# HISTORIC AND DESIGN REVIEW COMMISSION

**HDRC CASE NO:** 2018-353  
**ADDRESS:** 1011 S MAIN AVE  
**LEGAL DESCRIPTION:** NCB 2973 BLK 5 LOT 14 (CND LANDS & MEANS)  
**ZONING:** MF-33, HS  
**CITY COUNCIL DIST.:** 1  
**DISTRICT:** Nathan Historic District  
**LANDMARK:** House  
**APPLICANT:** David Hannan  
**OWNER:** Guadalupe Solis  
**TYPE OF WORK:** Construction of a rear addition  
**APPLICATION RECEIVED:** July 10, 2018  
**60-DAY REVIEW:** September 8, 2018  
**REQUEST:**

The applicant is requesting a Certificate of Appropriateness for approval to construct a rear addition of approximately 140 square feet at the rear of the historic structure. The proposed addition will be built atop an existing addition and will feature a wood deck and painted steel staircase.

**1** WEST ELEVATION

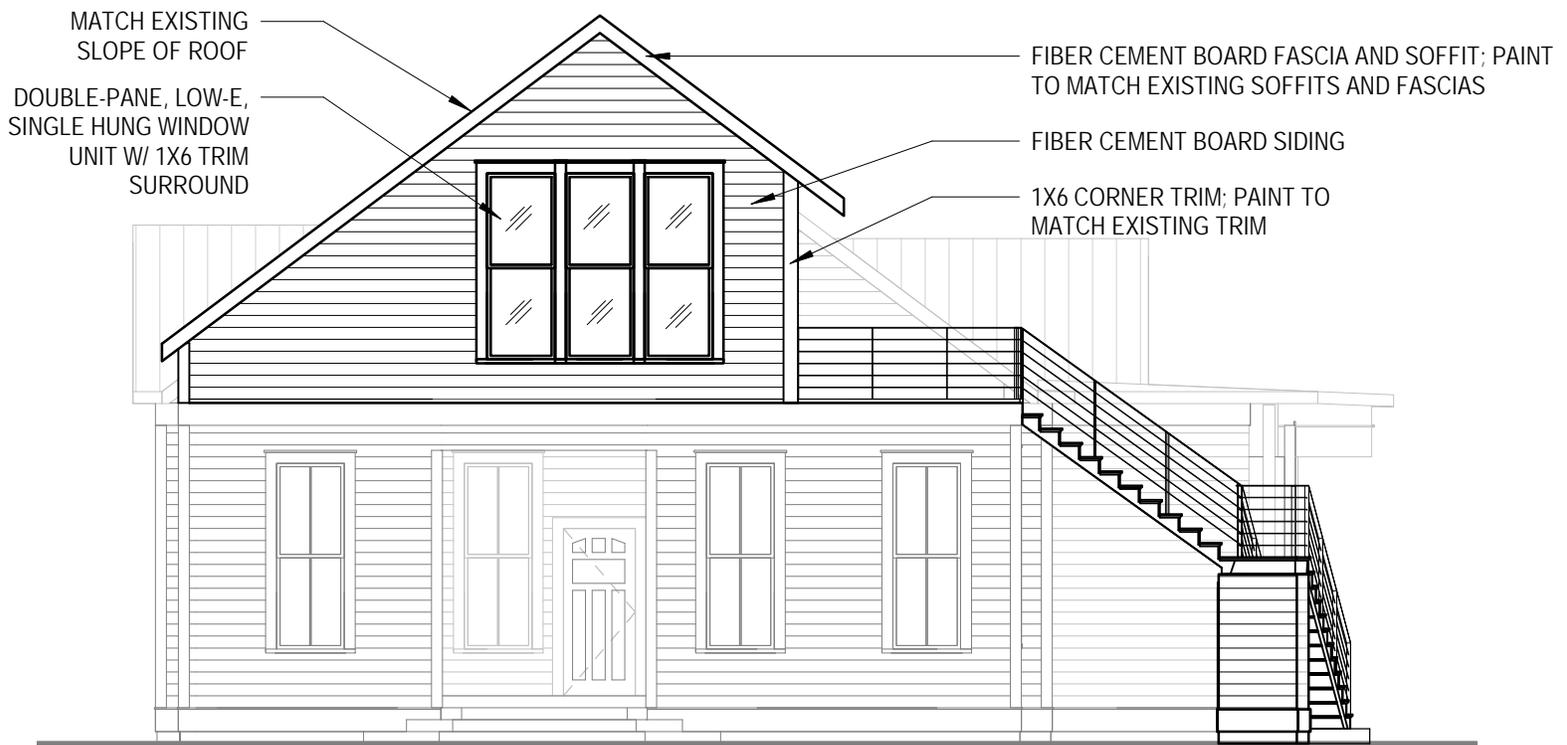
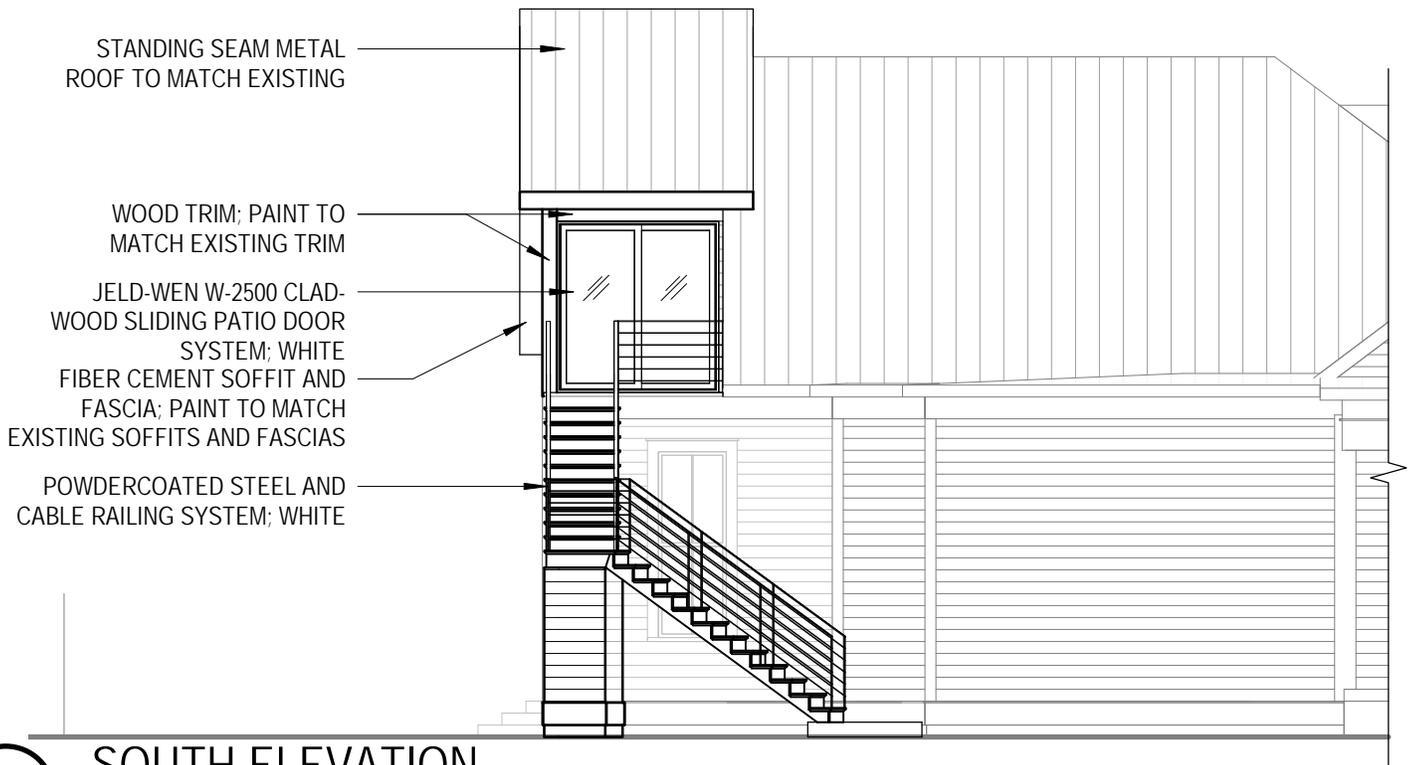
- c. **ROOF FORM** – The applicant has proposed for the addition to feature a rear facing gabled roof, which is consistent with roof forms found throughout the district as well as those found on the historic structure.

- e. **MATERIALS** – The applicant has proposed materials that include fiber cement siding and trim, double panel, vinyl-clad wood windows and a standing seam metal roof. Staff finds that the proposed fiber cement wood siding should feature an exposure of four inches and a smooth finish. The proposed standing seam metal roof is match the existing. Panels are to be 18 to 21 inches in width, seams are to be 1 to 2 inches in height, a crimped ridge seam is to be used and a standard galvalume finish is to be used.

- i. ACCESS STAIRCASE – To the south of the proposed addition, the applicant has proposed to construct a steel staircase with a powder coated steel and cable railing system. While the proposed materials are not found historically within the Nathan Historic District, staff finds them to be appropriate in the context of the proposed addition. Per the submitted construction documents, the proposed staircase will not extend further south than the extents of the historic structure’s wraparound porch. Given its distance from the primary facades of the structure and its lack of visual mass, staff finds its location and design to be appropriate. Staff finds that the proposed staircase should be painted green to match the primary color of the house to reduce visibility.

- i. That the proposed composite siding feature a smooth finish and an exposure of four inches.
- ii. That the proposed windows adhere to the specifications noted in finding f.
- iii. That the proposed staircase be painted to match the primary color of the house.

VIEWSHED

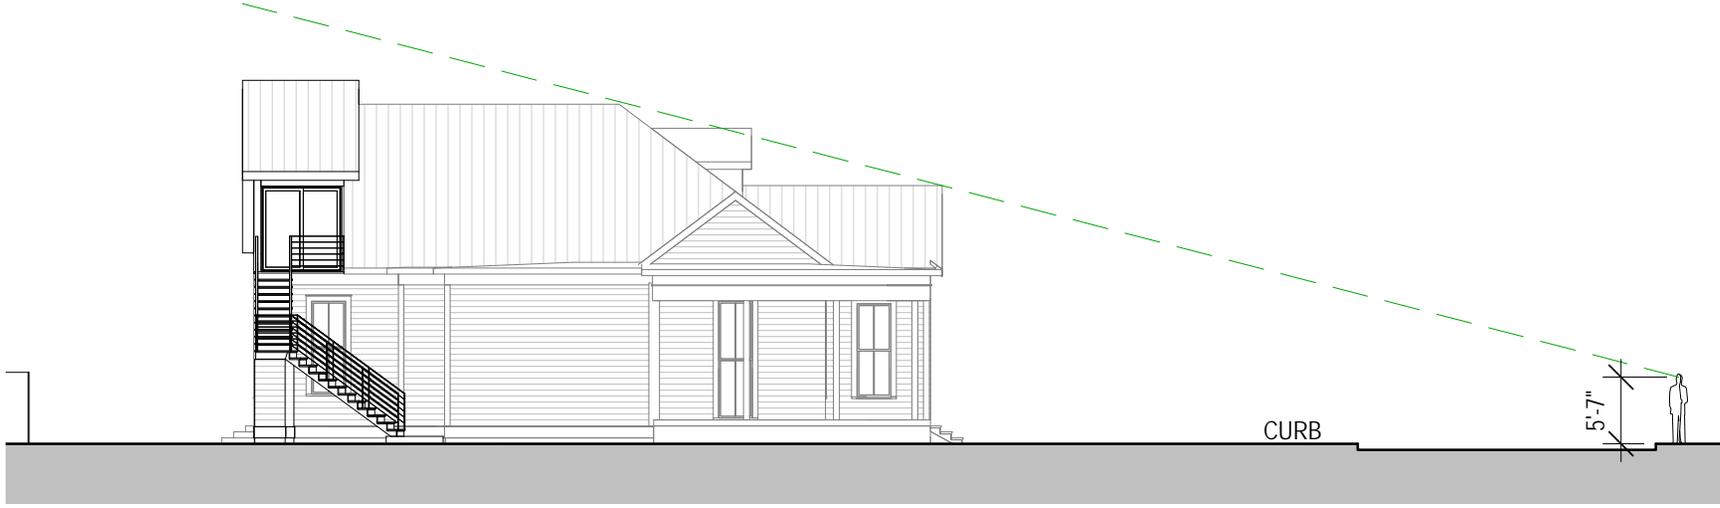
- d. **SCALE, MASS & FORM** –The proposed ridge line of the addition is dominant of that of the historic structure. The Guidelines for Additions 1.B. notes that additions should be subordinate to the principal façade and that the proposed height should consistent with that of the existing structure. The applicant has proposed for the addition to feature a ridgeline that is approximately two feet taller than the ridge line of the historic structure. Staff finds that the proposed addition should feature a ridgeline that is subordinate to that of the primary historic structure to be consistent with the Guidelines for Additions 1.B.v.; however, staff finds that through a line of sight study, the proposed addition may not be seen from the right of way at S Main and may be appropriate.
